Groundwater Application Review Summary Form

Application # G- 19350

PUBLIC INTEREST REVIEW FOR GROUNDWATER APPLICATIONS

A. GENERAL INFORMATION: Applicant's Name: Dig It Construction Inc. County: Lake

Water-Level Measurements in Nearby Wells

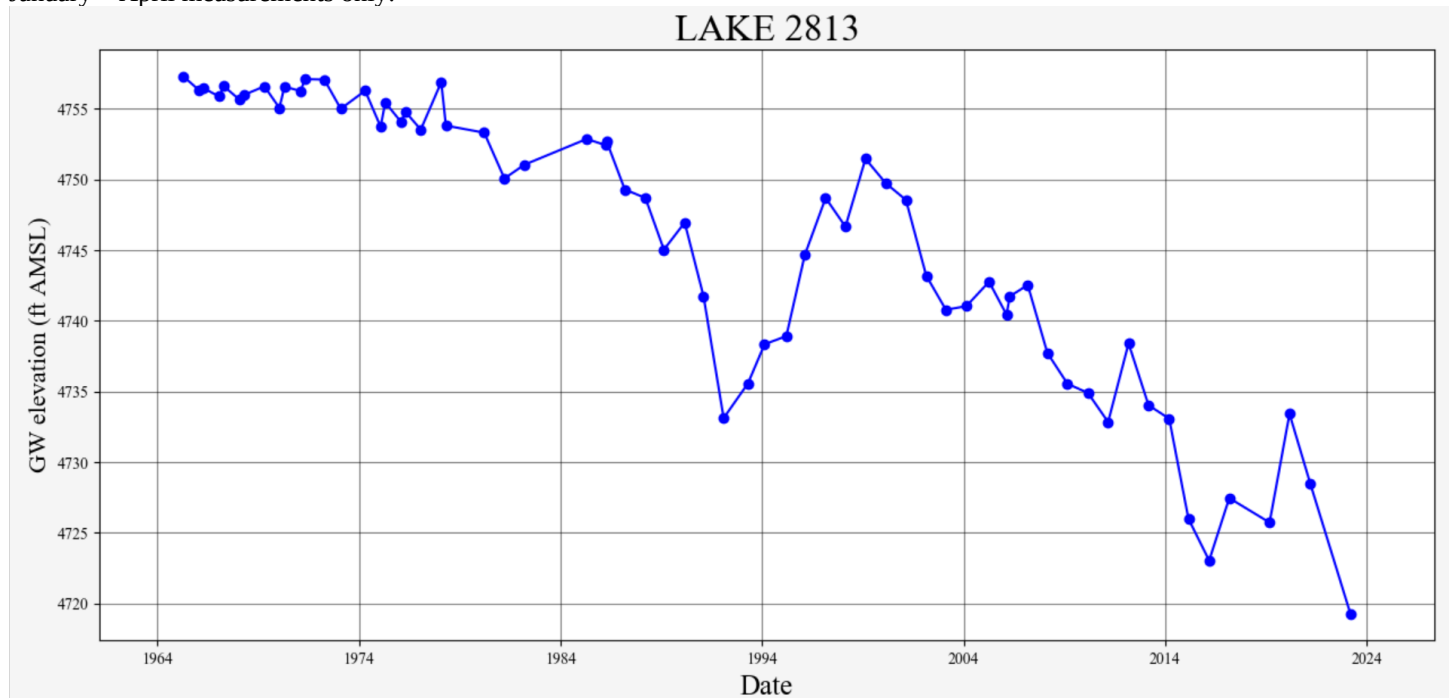
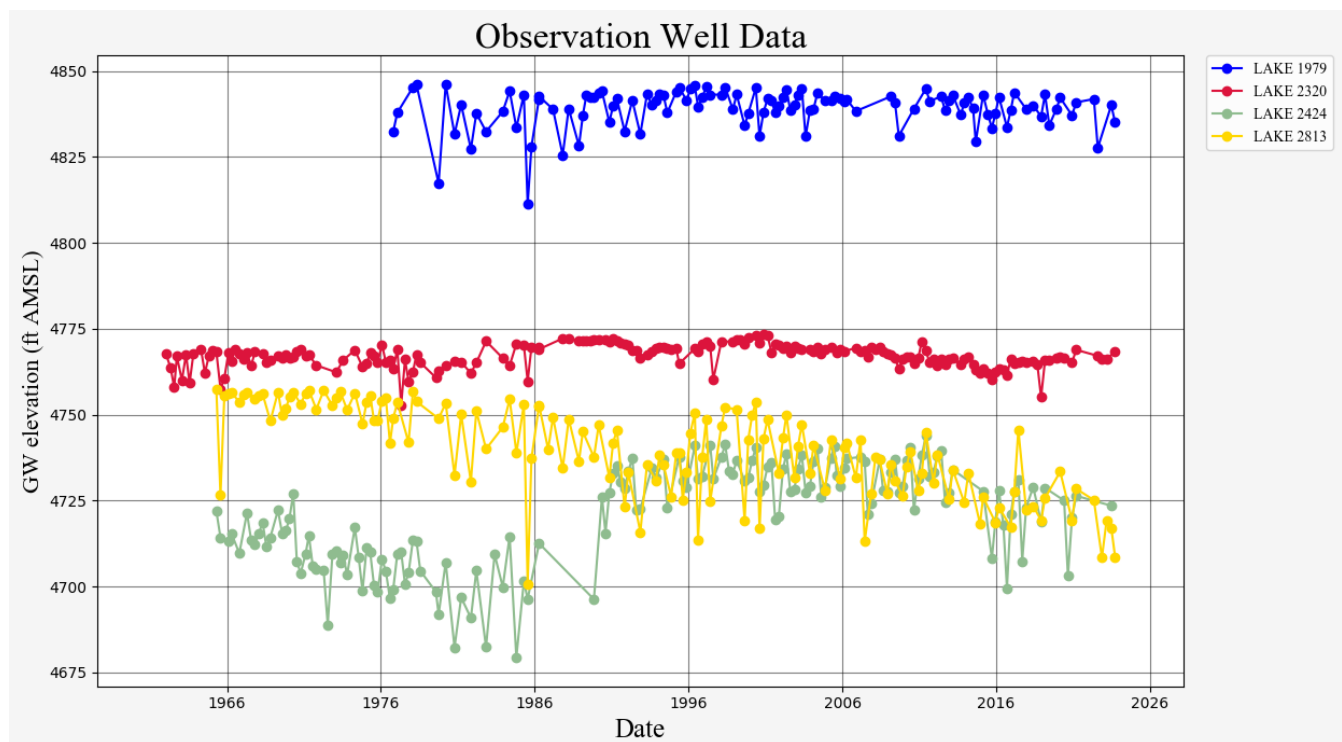
There are no time-series groundwater level data available for the upland area in the vicinity of the proposed wells. The nearest current State Observation Well LAKE 2813 is located over 5 miles to the southeast of the proposed wells. The water level record for LAKE 2813 records approximately 38 feet of overall decline since 1965. Other State Observation Wells in the Goose Lake Subbasin (LAKE 1979; LAKE 2320; LAKE 2424) show no indication of a long-term year-to-year decline trend over the period of record. Given the distance between the proposed wells and observation wells with available groundwater level data, and the differences in geology and position within the groundwater flow system, it is not likely that any of these groundwater level records are representative of groundwater conditions at the location of the proposed wells.

There is very little groundwater development in the immediate vicinity of the proposed wells. The available water level record does not meet the Division 8 definition of excessively declining or declined excessively (for the storage portion of the source of water to wells).
